### Addendum No. 1

#### Cobbs Creek Playground (700 Cobbs Creek Parkway)

#### Philadelphia Redevelopment Authority

Issue Date: August 18, 2022

**1** ELECTRICAL SITE PLAN  
 E-100 Scale: 1/16" = 1'-0"

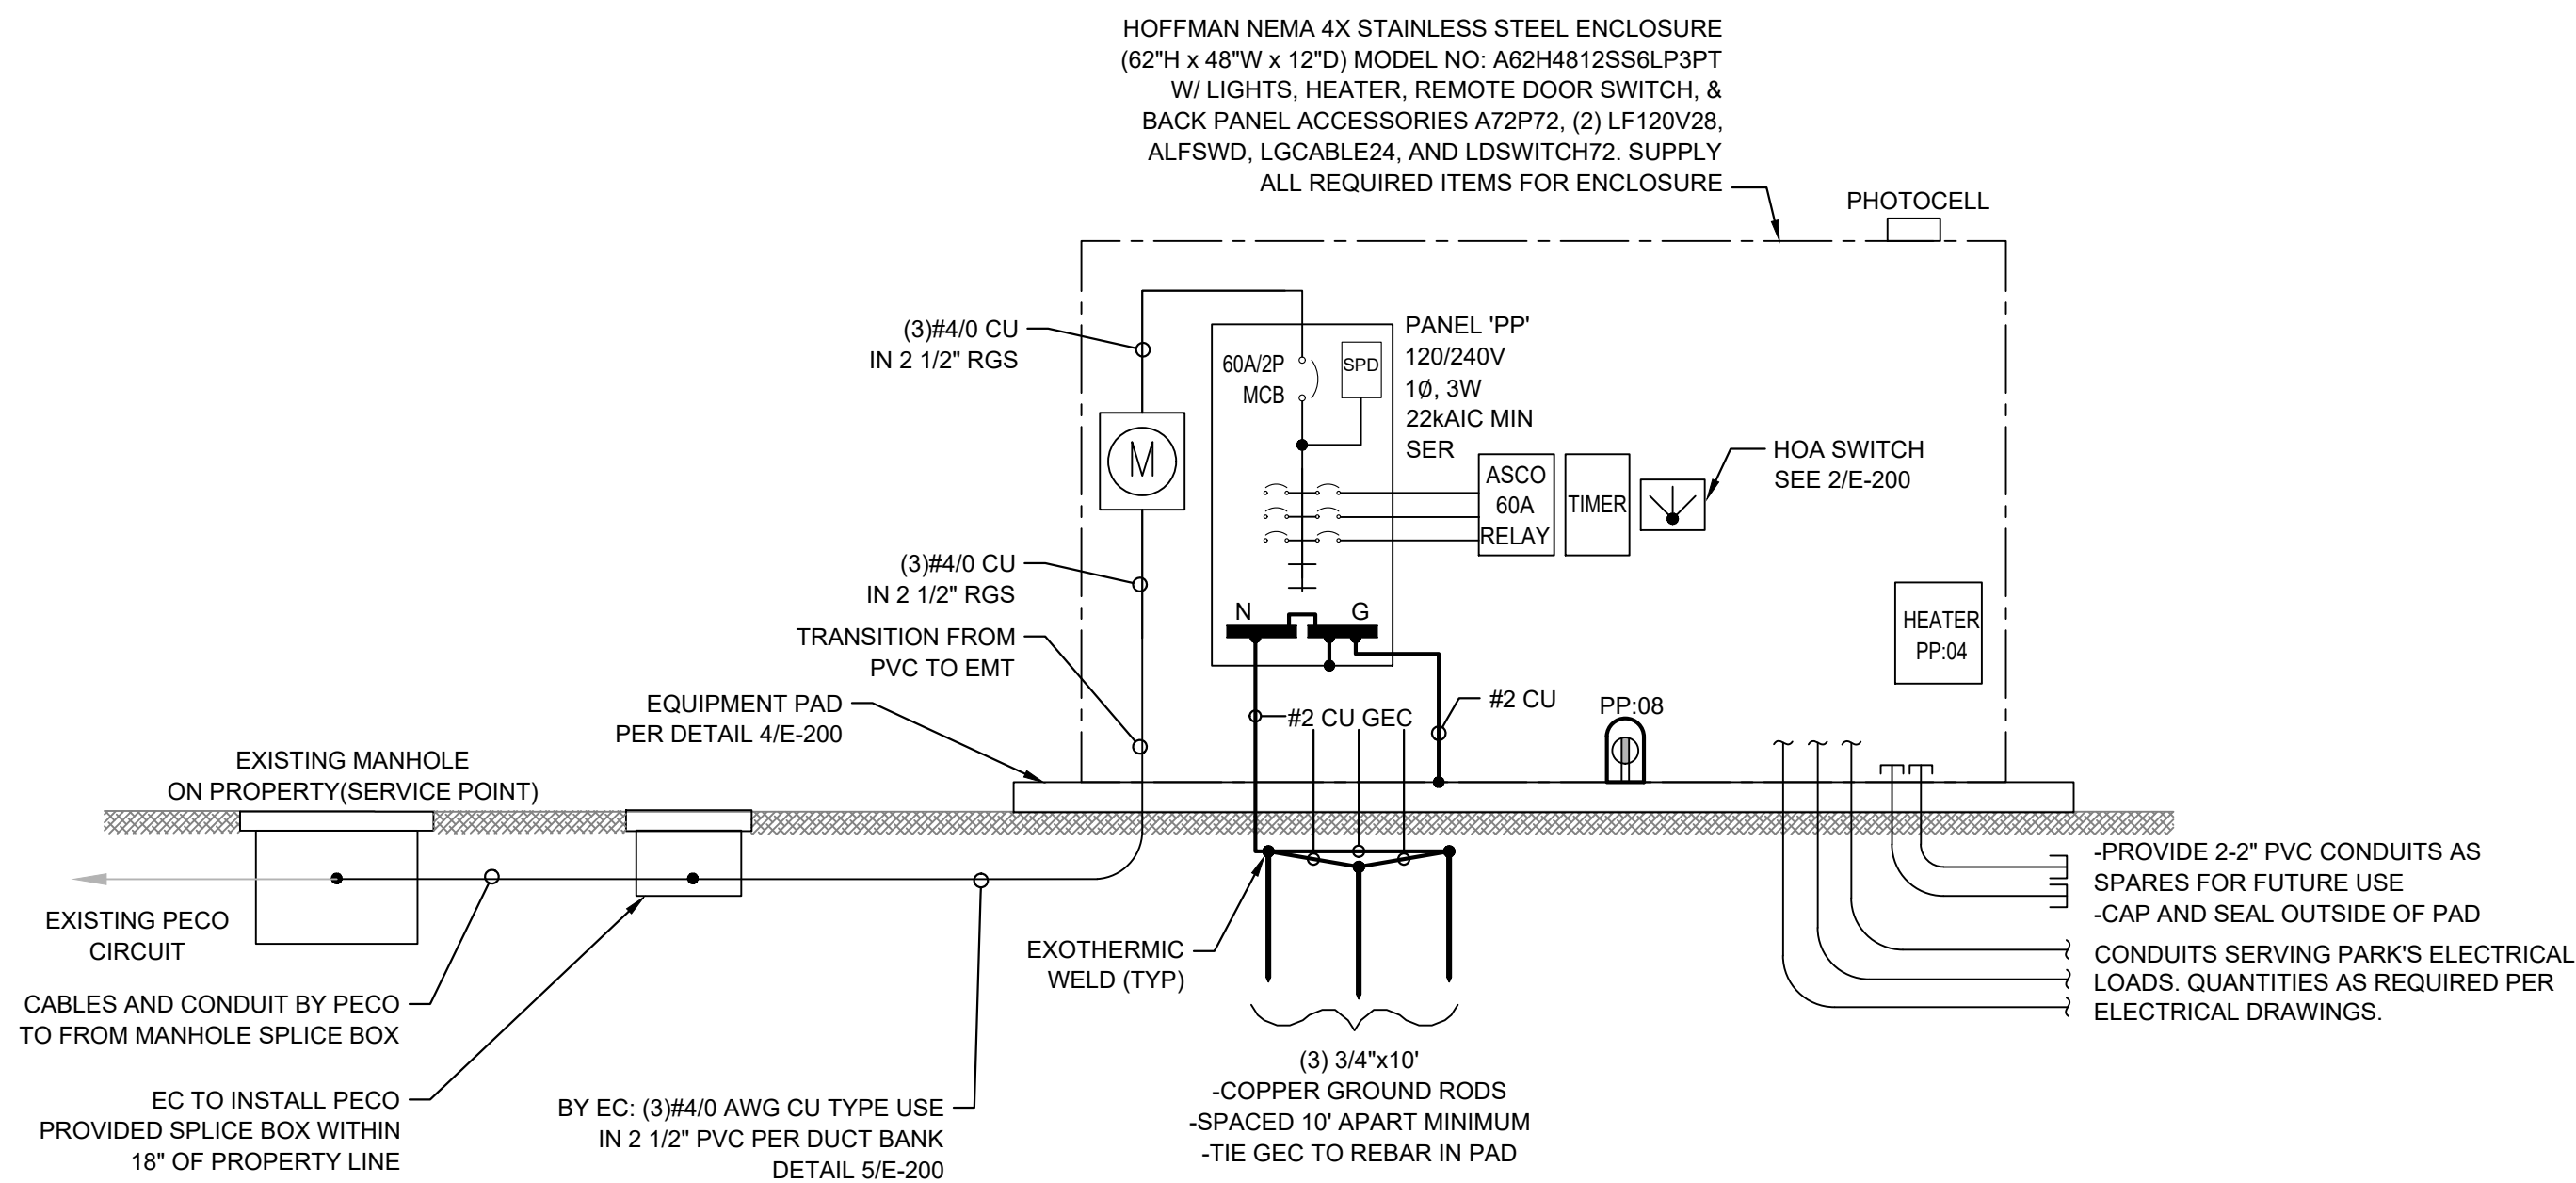
- I. E-100 Electrical Site Plan
  - i. Added notes re: existing electrical and splice box.
  - ii. Added notes re: existing fiber line.
  - iii. Revised Keyed Notes.
- m. E-200 - Details
  - i. Detail 2 – deleted note 2.
  - ii. Revised details 6, 7, 8.

1. Drawing E-100: Keyed Note #9 – Can you provide a location or distance for bid purposes of the “City Underground Pull Box” for the fiber optic line needed for CCTV?

- (c) Note #4 on E-100 point of connection appears to be in the asphalt walkway but identifies it as the parkway which is outside the curb line. C-200 shows the existing electric line between the fragmented curb and guard rail, Please clarify the correct location of the splice box on the drawings.

Response: Contractor to intercept existing underground conduit with new handhole. The existing underground handhole located adjacent to the existing light pole with CCTV cameras (located along the road to the Environmental Center Building) is approximately 170’ north of the new handhole. Refer to the updated drawing E-100 for additional information.

Response: Contractor to install the splice box adjacent to the existing manhole on the property. Final location to be coordinated/approved by PECO. Refer to the updated drawing E-100 for additional information.
